Wisconsin Department of Transportation

Proposal #08: 1595-09-73, WISC 202390
Bradley - Rhinelander
North Rifle Road to STH 47
USH 8
Oneida County

This is Addendum No. 02, which provides for the following:

ADDENDUM NO. 02

Addendum No. 02
 ID 1595-09-73
 Revised Sheet 10
 April 6, 2023

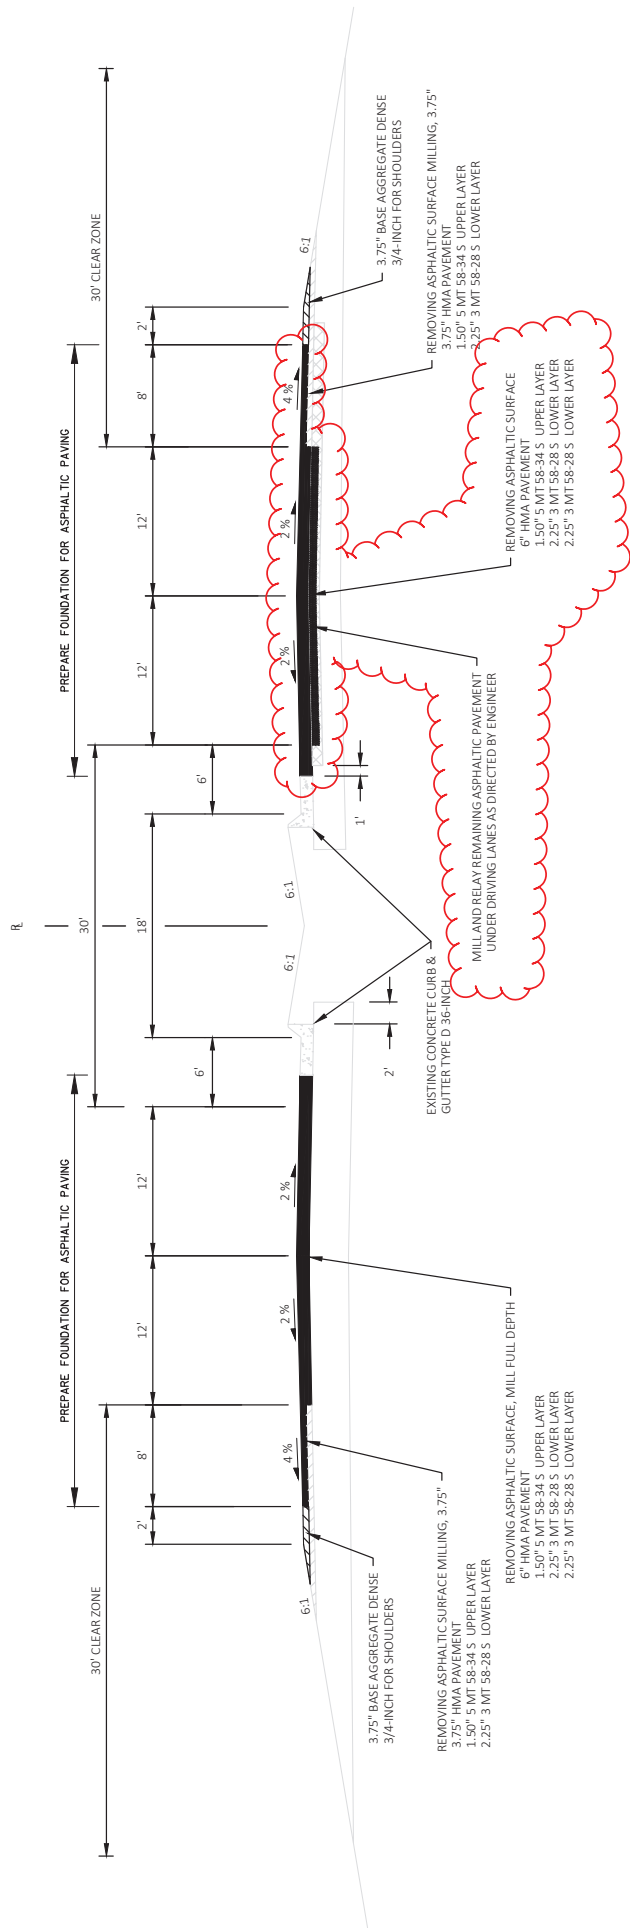
Revised Plan Sheets	
Plan Sheet	Plan Sheet Title (brief description of changes to sheet)
10	Add detail to mill and relay" of existing asphaltic base coarse
11	Add detail to mill and relay" of existing asphaltic base coarse
12	Add detail to mill and relay" of existing asphaltic base coarse
17	Revised language in the construction notes
45	Revised 1-1/4" base agg quantity, added asphaltic surface temp
49	Add quantities for turtle exclusion barrier

Addendum No. 02
ID 1595-09-73
Added Sheet 15A
April 6, 2023

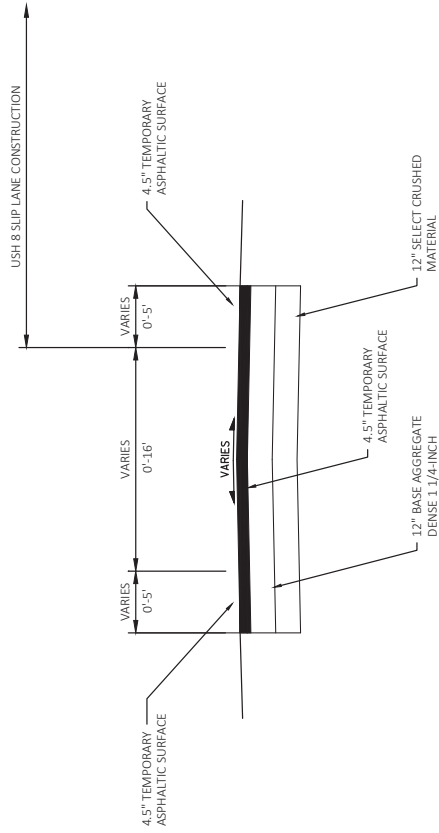
Added Plan Sheets	
Plan Sheet	Plan Sheet Title (brief description of why sheet was added)
15A	Added crossover construction detail
20A	Added turtle exclusion barrier detail sheet
